Subject: Objection to HGY/2024/0506

Case Reference: HGY/2024/0506

Location: 42 Seymour Road, Hornsey London, N8 0BE

CONSULTATION
RESPONSE: MARK-UP
OF SUBMITTED
DRAWINGS
28/04/24

Fig 3. Photo of existing chimney breast

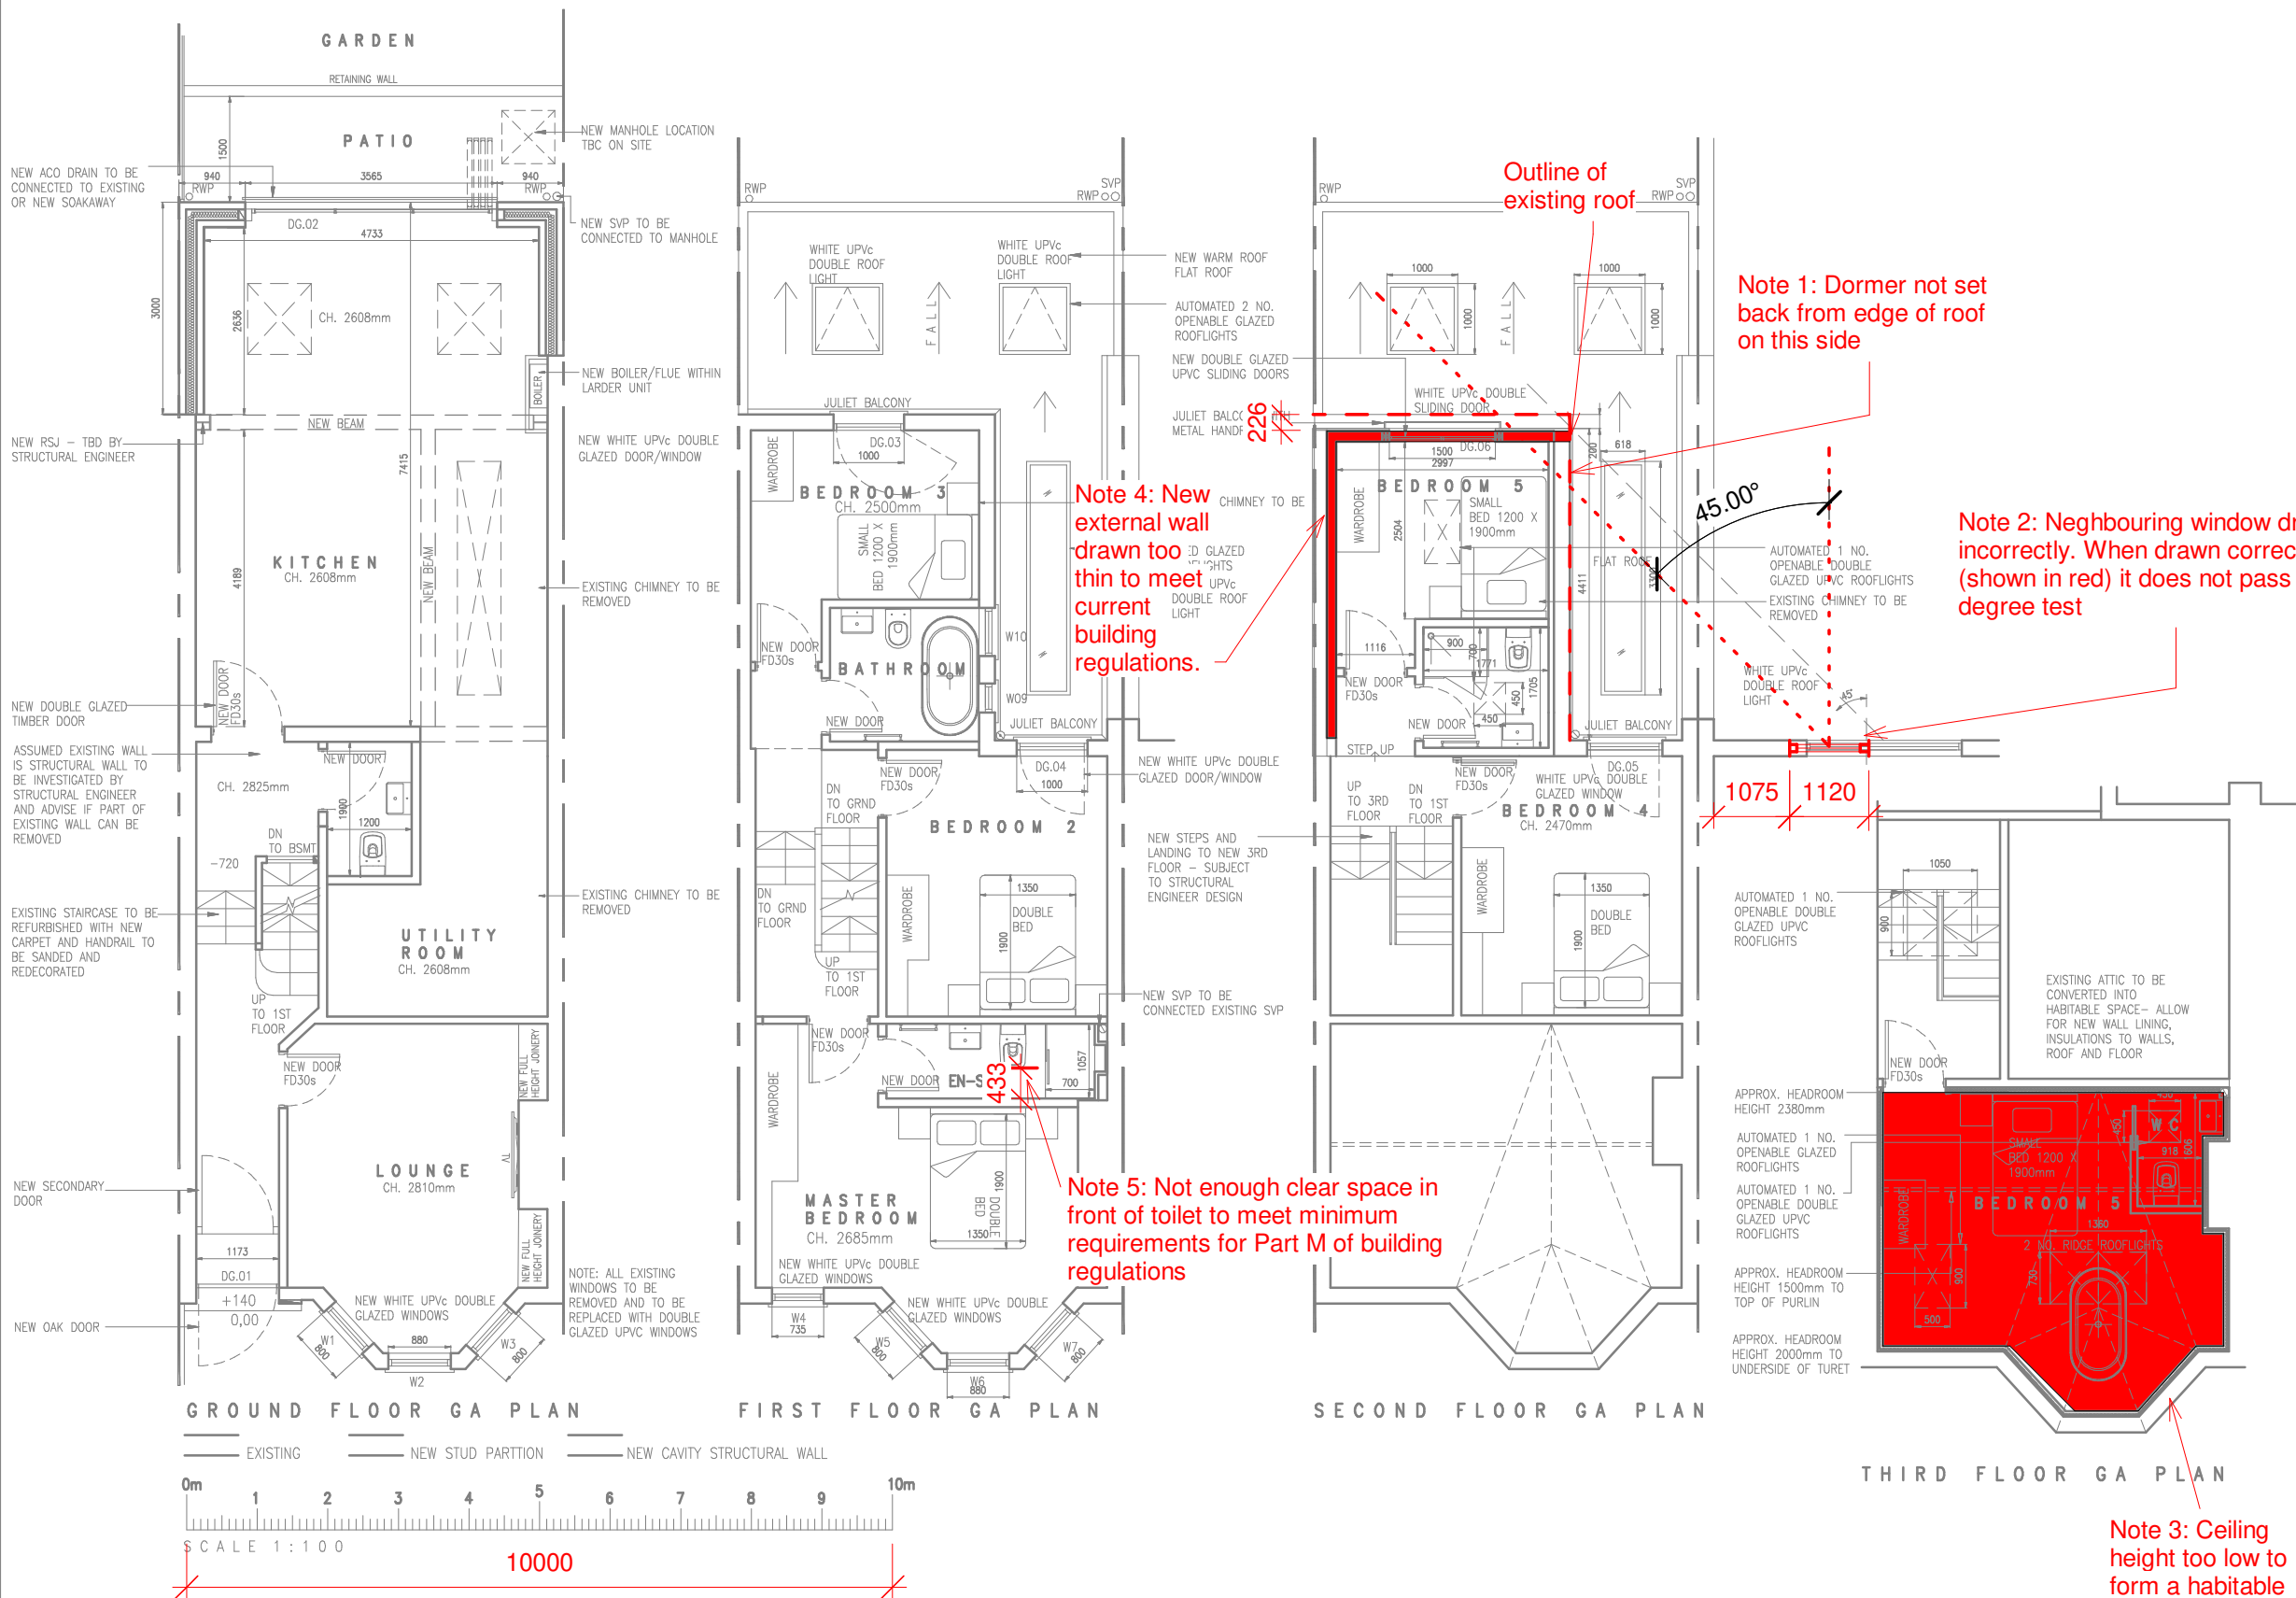
- The gable end, which includes the chimney breast shared with 40 Seymour Road, has been incorrectly drawn on the existing drawings showing massing that does not exist (see marked up existing North-east, North-west elevations), this should also be labelled up as new brickwork on all the proposed drawings (See marked up North-east, North-west elevations). See Figure 3 (overleaf) showing the actual built form and note 6 of marked up drawings.

B	23/03/24	ISSUED TO CLIENT FOR COMMENTS	VP
A	27/10/23	ISSUED TO CLIENT FOR COMMENTS	VP
REV.	DATE	PURPOSE	DRAWN
CLIENT	Mr SANJ BUNDHOO		
PROJECT	SIDE AND REAR EXTENSION		
TITLE	PROPOSED GENERAL ARRANGEMENT PLANS		
REVISION	DWG No.	FP/103	SCALE 1:100@ A3
B	DATE	OCT '23	DRAWN VP

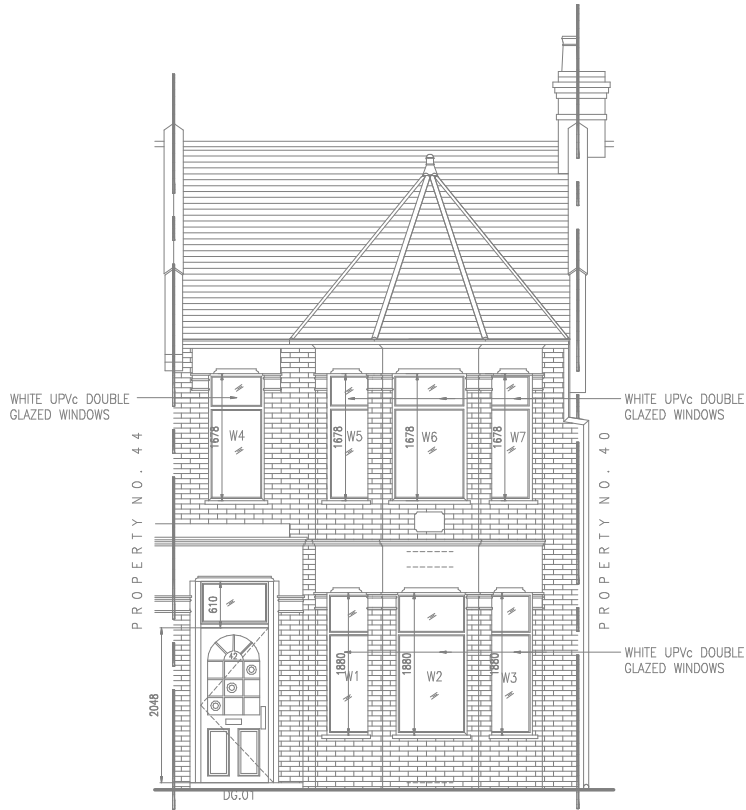
The submitted proposed drawings **have not** accurately surveyed the window location and width to the habitable room at first floor level of the adjacent property (40 Seymour Road) and actively misleads in the assessment of the proposals impact on habitable rooms. This proposal would result in the inappropriate loss of daylight and sunlight to the adjacent property relating to **Part D(a)** of

Policy DM1 of Haringey's Development Management DPD (2017). Please see note 2 on the supporting marked up drawings, showing corrections to the submitted plans and correct location of the 45-degree line.

- The adjacent property window at 40 Seymour Road (see note 2 of marked up drawings) has been shown by the applicant as significantly wider than the window measures. This results in the 45-degree line incorrectly set on the plans submitted by the applicant and will be misleading when assessing the impact of the outrigger extension on habitable rooms under **Part D(a) of Policy DM1** of Haringey's Development Management DPD (2017).

- The labelling of bedrooms on the second floor are duplicated with two bedrooms labelled as bedroom 5. This objection letter will refer to the proposed bedroom within the outrigger roof extension as bedroom 5 and the proposed bedroom within the existing roof to the front of the dwelling as bedroom 6 for clarity.

- The submitted drawings have drawn the new external walls too thin to meet current building regulations. This gives a misleading impression of the set back and will impact on the internal space of bedroom 5. (See note 4 of marked up drawings)

- The new ensuite bathroom of the master bedroom does not have enough clear space in front of the toilet to meet *minimum* requirements for Part M of building regulations. (See note 5 of marked up drawings)

REVISION	DWG No.	FP/102	SCALE	1:100@ A3
B	DATE	OCT '23	DRAWN	VP

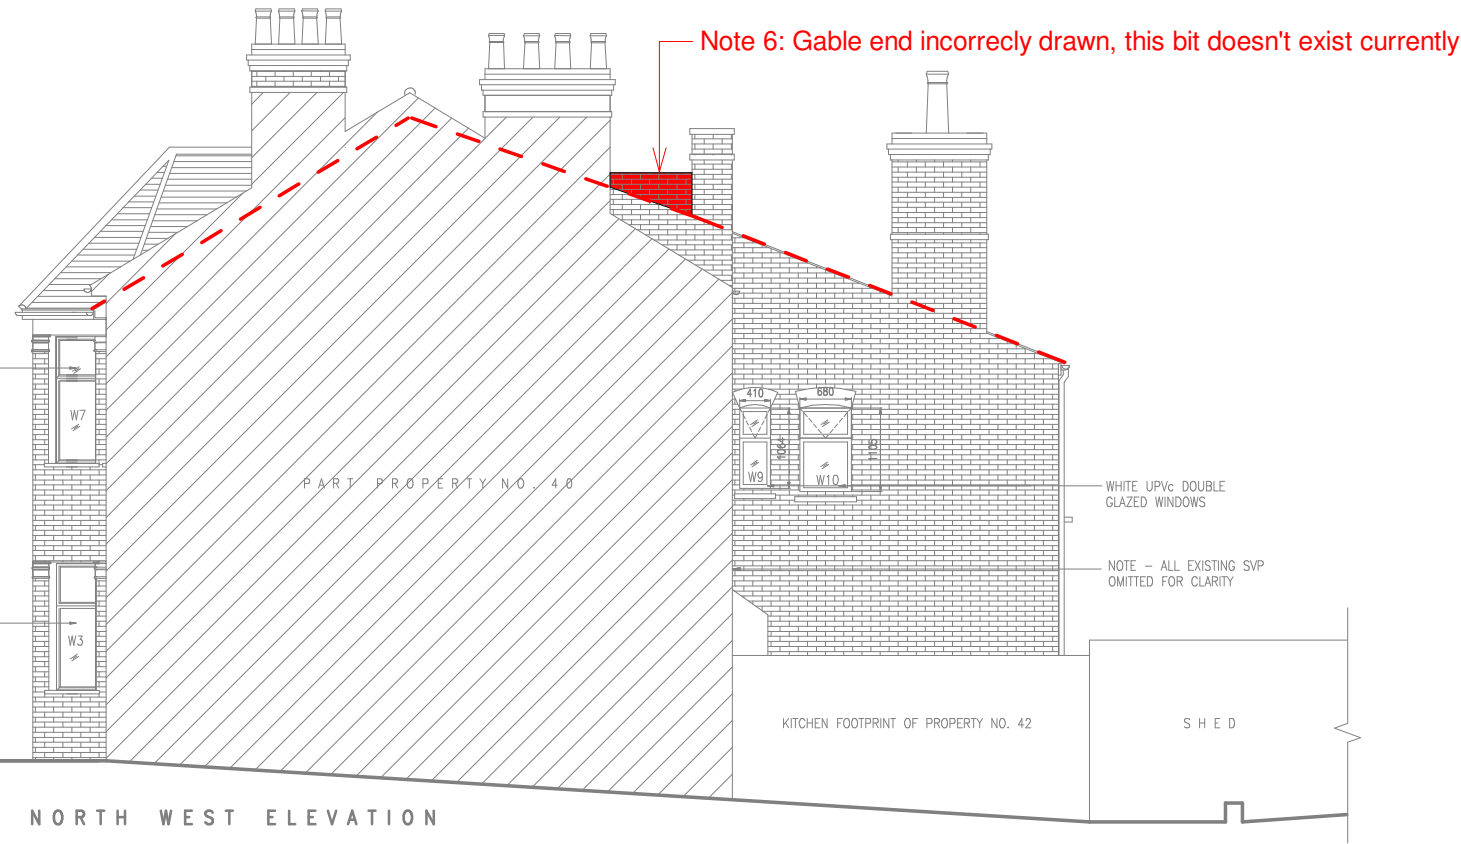
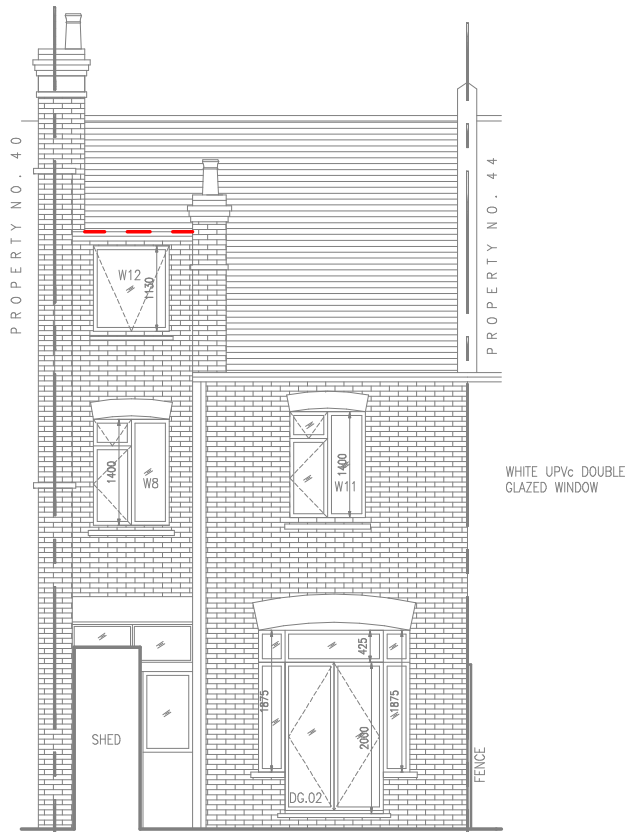
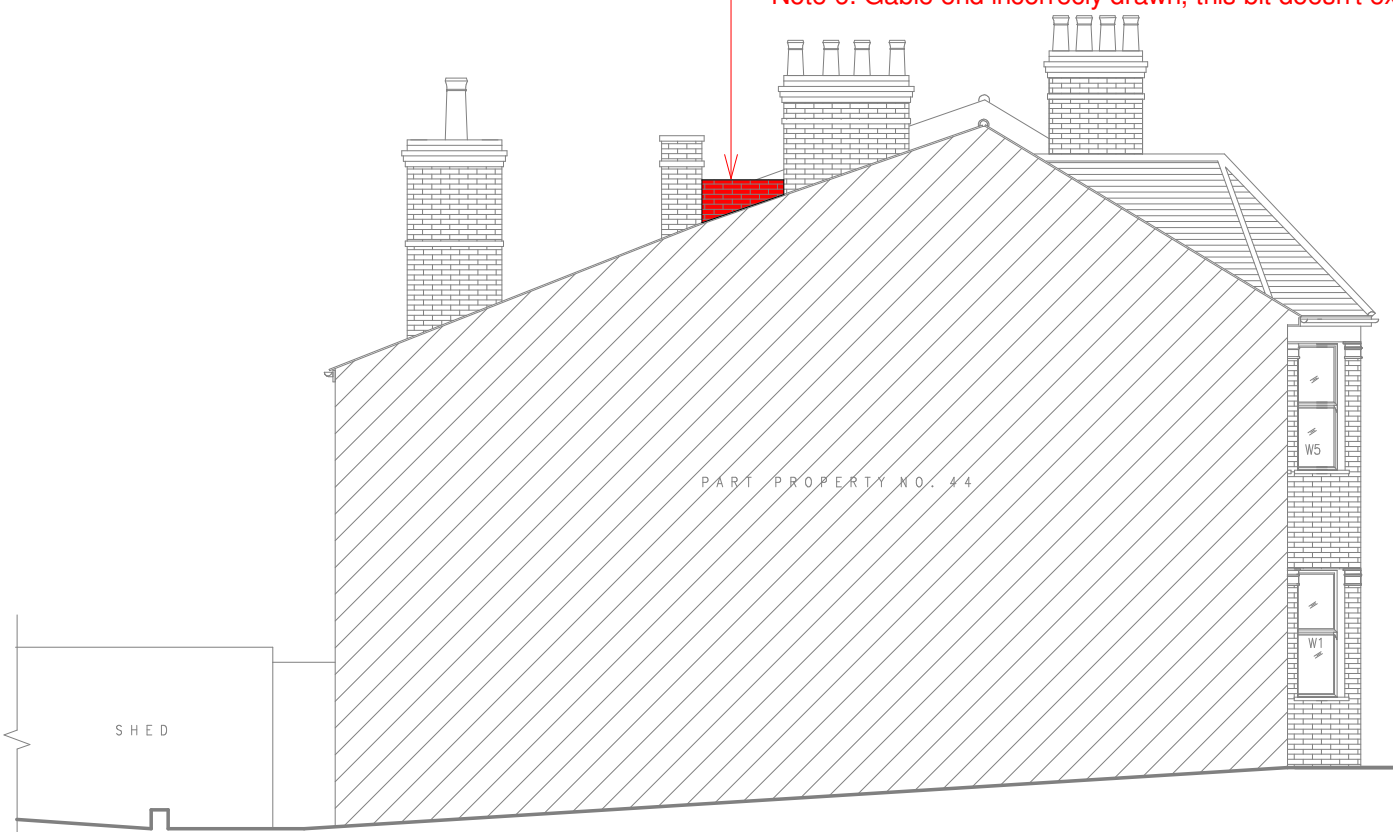
- The proposed Northwest elevation labels the adjacent property as 44 Seymour Road, this is incorrect and should be labelled 40 Seymour Road.
- The existing and proposed north and south elevations, show the ridge height of 42 Seymour Road (development proposal) as the same level as 40 Seymour Road. This is incorrect, the ridge height of 40 Seymour Road is set higher. The ridge height of 42 Seymour Road does align with the ridge height of 44 Seymour Road; this is shown correctly in the drawings (see figure 5, overleaf).

B	23/03/24	ISSUED TO CLIENT FOR COMMENTS	VP
A	27/10/23	ISSUED TO CLIENT FOR COMMENTS	VP
REV.	DATE	PURPOSE	DRAWN
CLIENT Mr SANJ BUNDHOO			
PROJECT SIDE AND REAR EXTENSION			
TITLE EXISTING AND PROPOSED INTERNAL SECTIONS			
REVISION	DWG No.	FP/104	SCALE 1:100@ A3
B	DATE	OCT '23	DRAWN VP

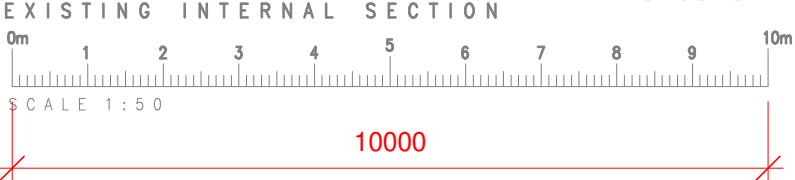
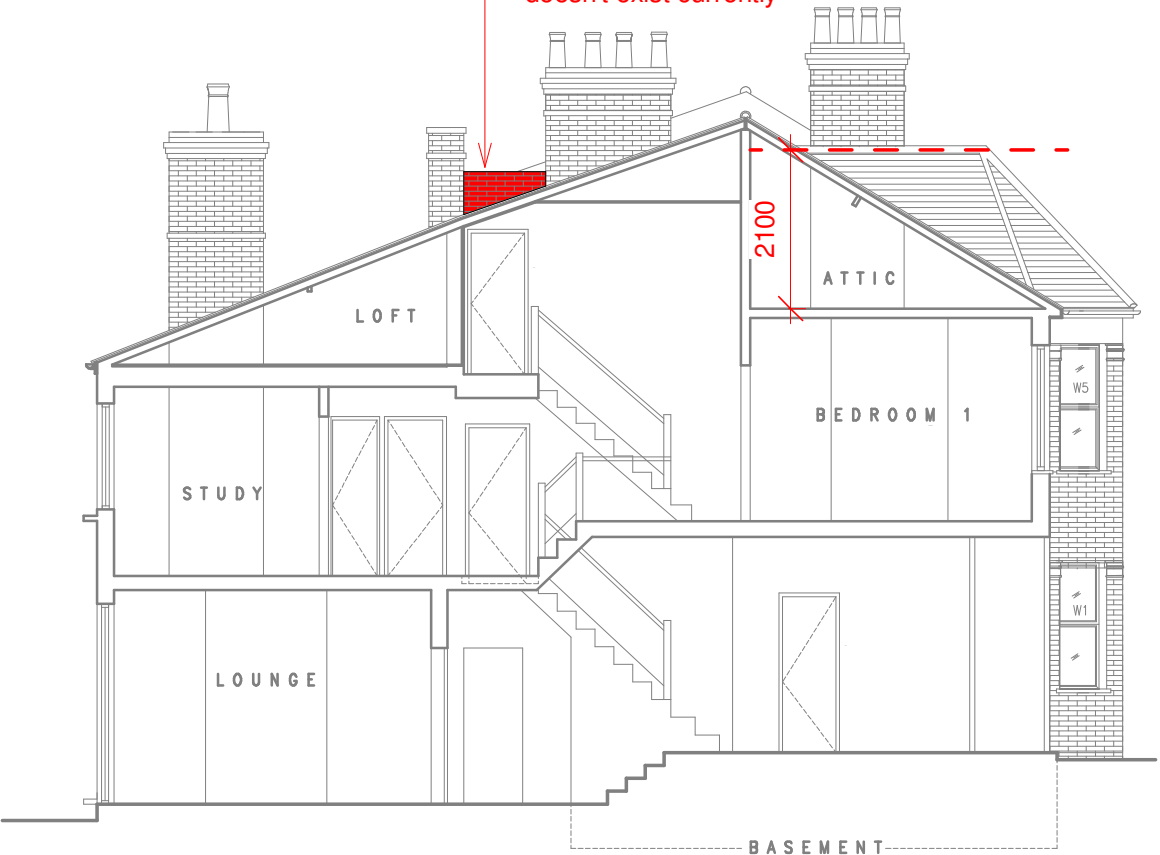
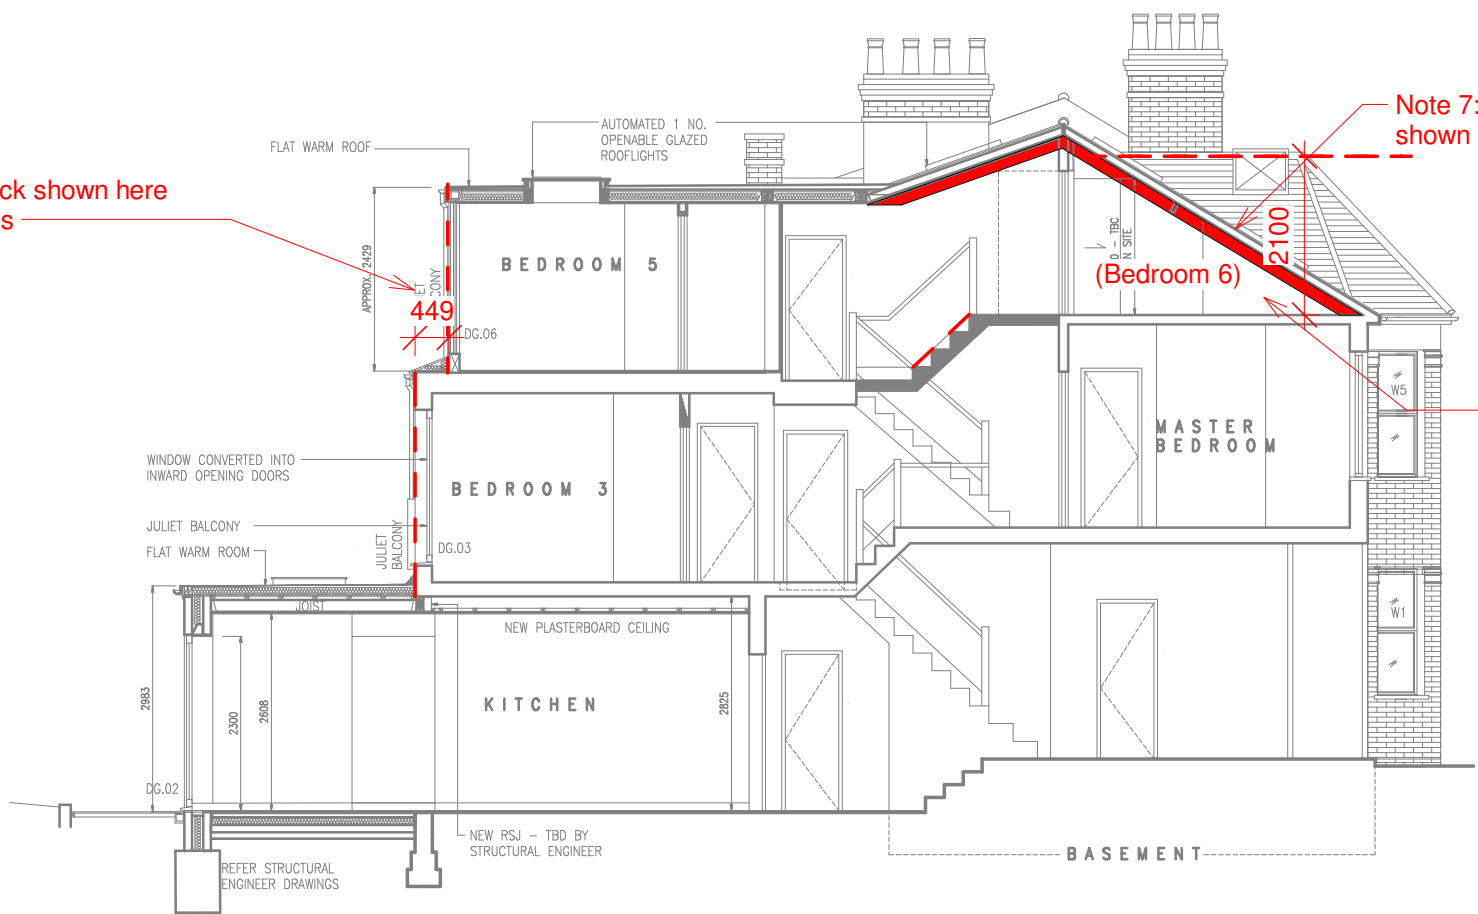
- The new bedroom (bedroom 6 in marked up plans) within the main roof of the dwelling will not be a habitable space due to ceiling heights being too low (see note 3). The applicant submitted drawings which did not show the depth of the insulation which is labelled on the floor plans and required for to make the loft a habitable room under building regulations (see note 7 of marked up drawing). This will reduce the head height in this space even further. This room will also have no external window with natural light only provided through rooflights (See proposed third floor plan and proposed internal section of marked up drawings).

Note 8: Bigger set-back shown here than on other drawings

Note 7: Insulation to make loft space habitable not shown in section as labelled on plan.

Note 3: Ceiling height already too low to make a habitable room
